Addendum

DATE: April 23, 2020
TO: Bidders
FROM: Mike Carrithers, Purchasing Agent
RE: **Addendum 2** – Bid 010501 Dishwasher Replacement at Centennial High School

Trench backfill and repair detail

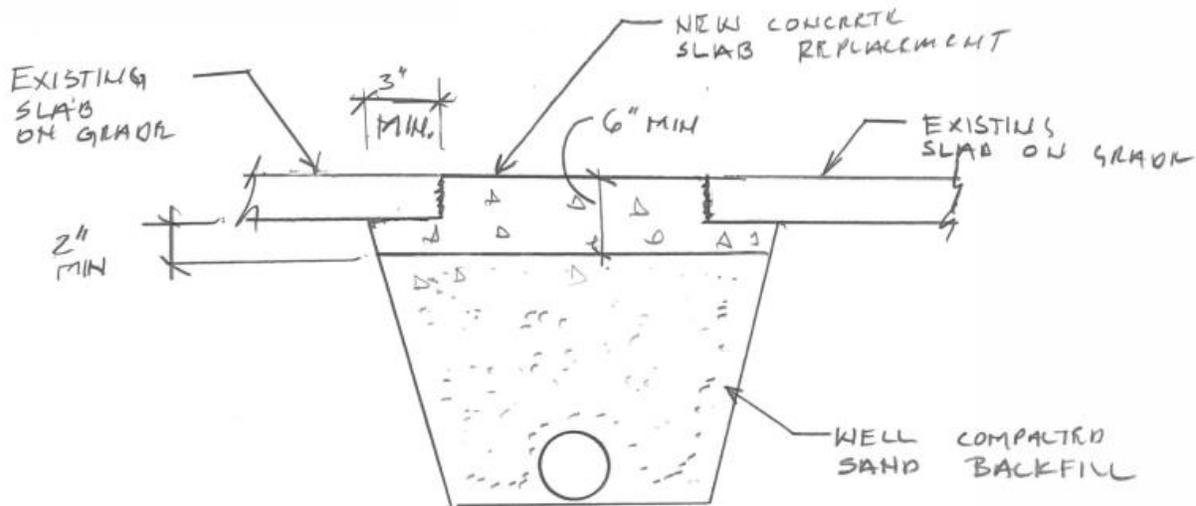
Q: What are the pour back reinforcement requirements for rebar in the trench?

A: Patch per industry standard and local code. Place rebar parallel to the length of the trench at 6" on center and place a hand tooled joint half way down the trench.
